6 May 2024

Re: Response to Submissions (RtS) - SSD- 36138263
Augusta Street Warehouse and Distribution Centre
Augusta Street, Blacktown, NSW

In response to the letter from Blacktown City Council dated 12 April 2024 referenced MC-23-00005, we provide the following responses to the Civil Engineering and Drainage matters.

Figure 2 – Basin 1 and areas where solar access is reviewed in section.

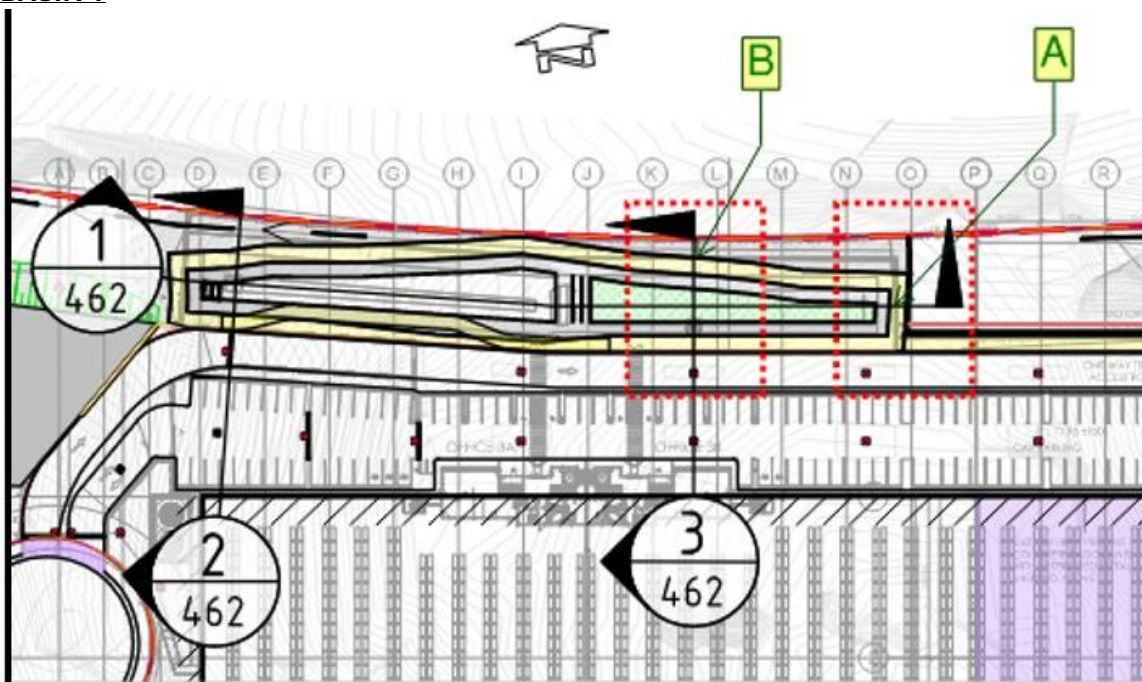
Furthermore, the solar access of both basins is uncertain. The consultant shall confirm the basin meet the minimum solar access.	Solar access have been reviewed and response provided in Enclosure 1 to this letter.

Minimum Solar Access considered to be achievable. Retaining wall heights to be confirmed during detail design stage. Estimated 1 in 1.5 mid-winter shadow line considered to be clear of bioretention basins based on the concept retaining wall heights.

Figure 3 – Section A through Basin 1

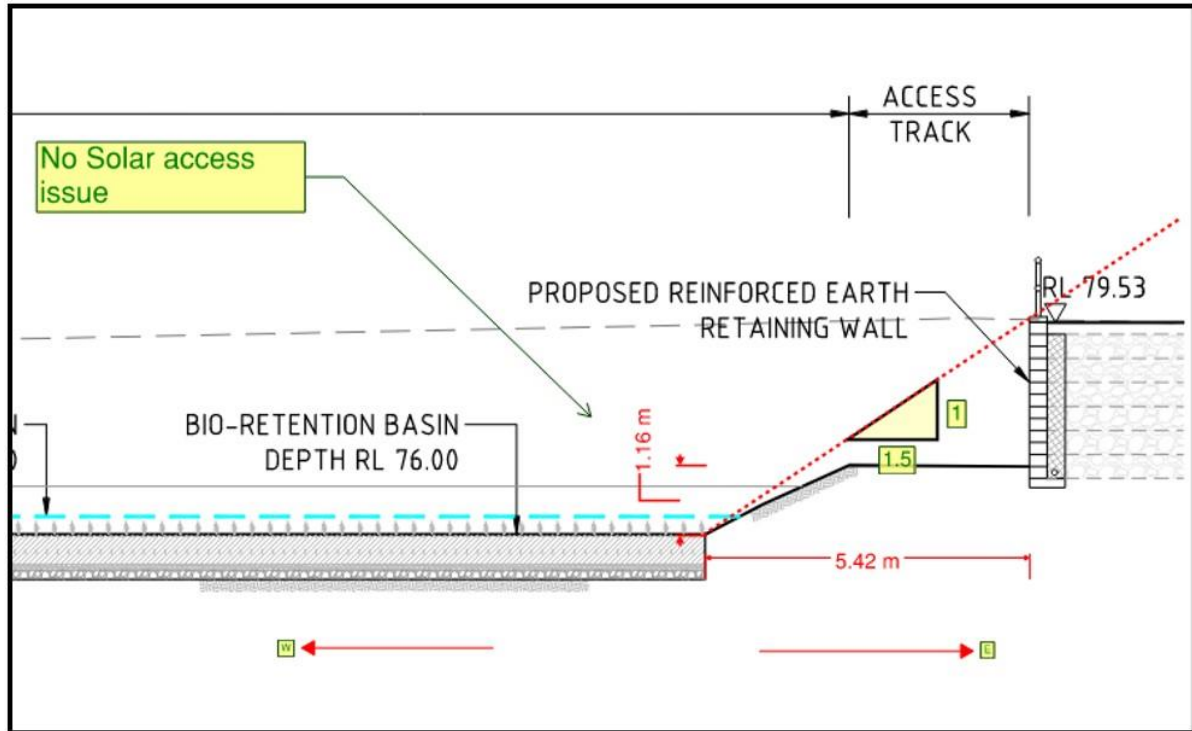
Section A:

Figure 4 – Section B through Basin 1

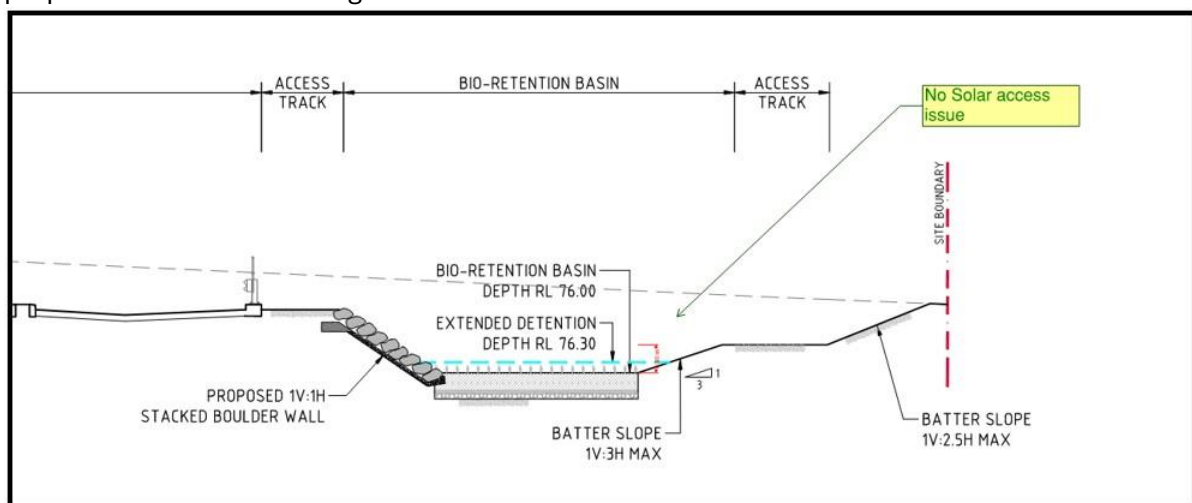
Section B:

Minimum Solar Access considered to be achievable, no high structures towards the north of the proposed bioretention along this section.

Figure 5 – Basin 2 & 3 and areas where solar access is reviewed in section.

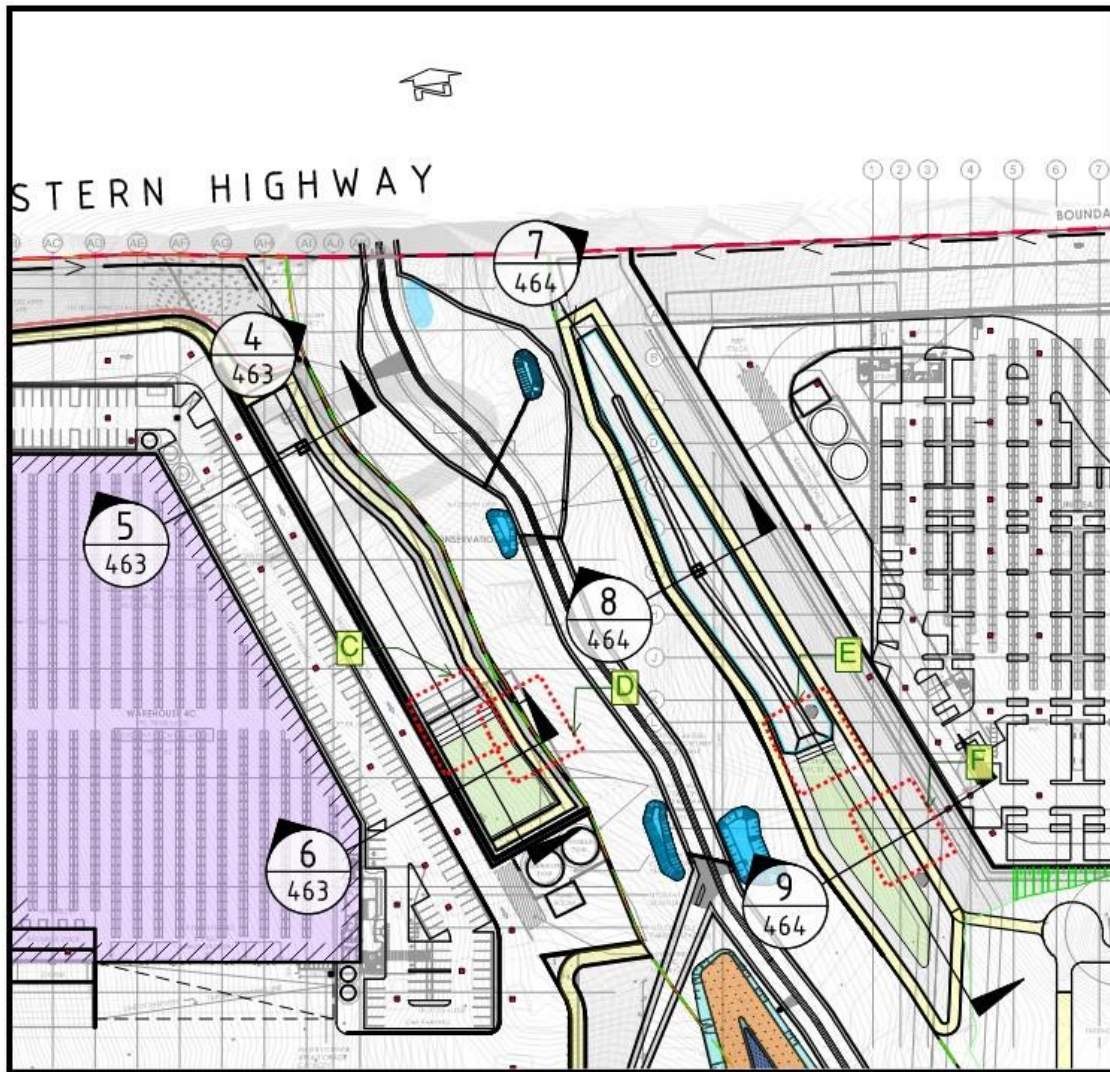
An additional review of the architectural shadow study (referenced 220207-DA-003, dated Aug 2023) have been conducted. Bioretention Basin number 3 experience shadowing from warehouse 5 between 9am and 12pm. Refer to figure

Figure 7 – Section C through Basin 2

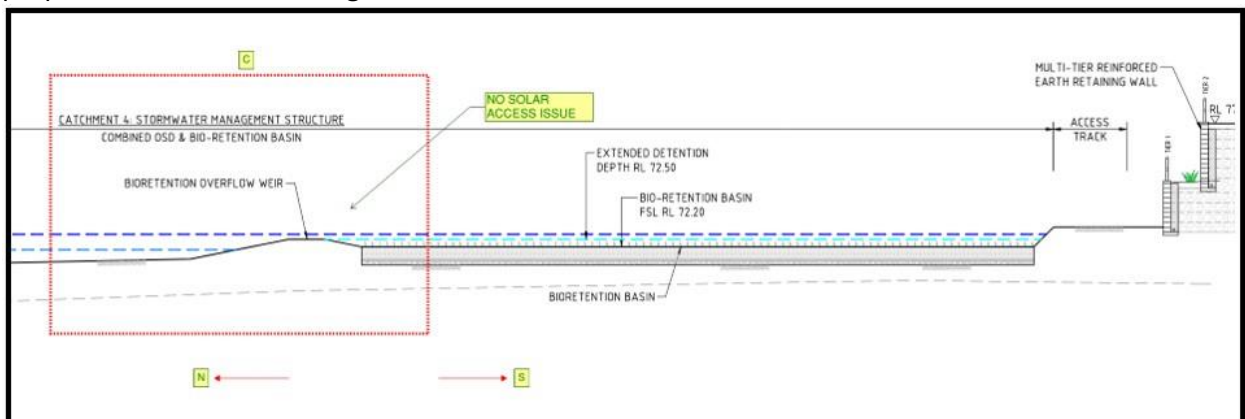
Section C:

Minimum Solar Access considered to be achievable, no high structures towards the north of the proposed bioretention along this section.

Figure 8 – Section D through Basin 2

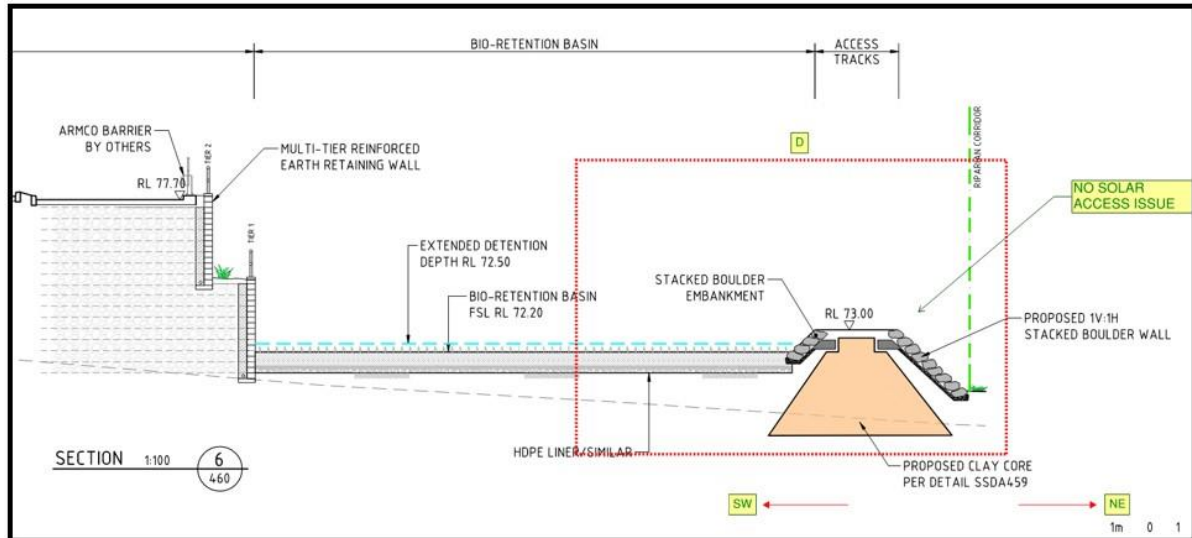
Section D:

Minimum Solar Access considered to be achievable, no high structures towards the north of the proposed bioretention along this section.

Figure 9 – Section E through Basin 3

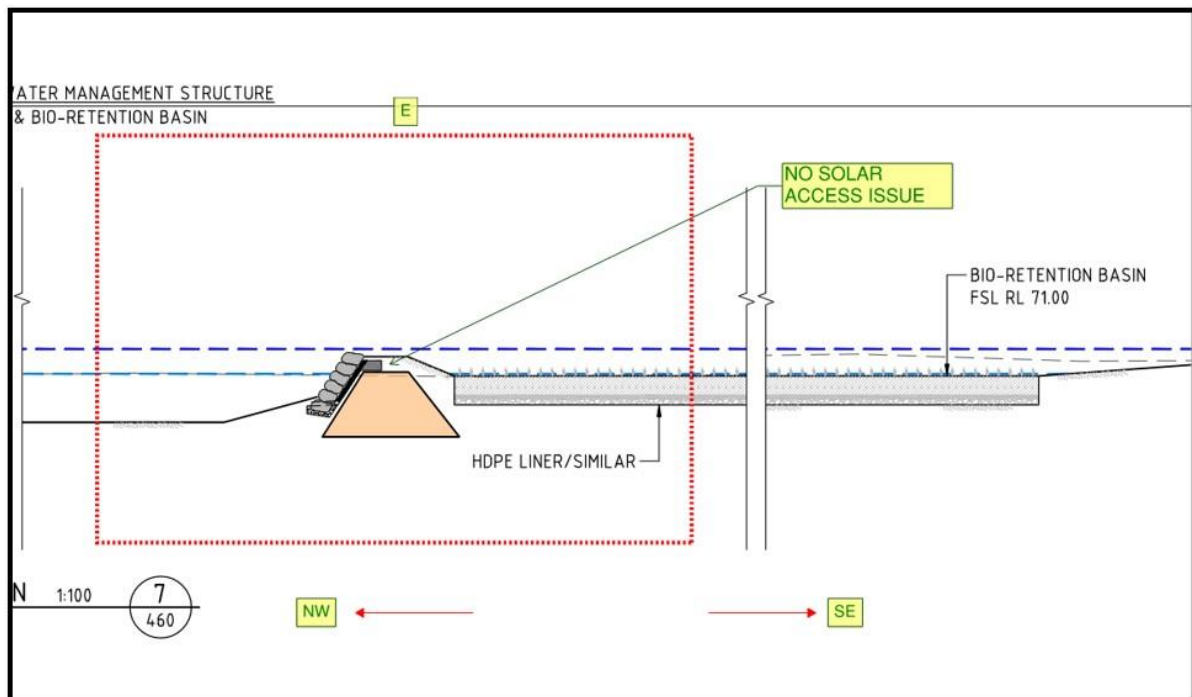
Section E:

Minimum Solar Access considered to be achievable.
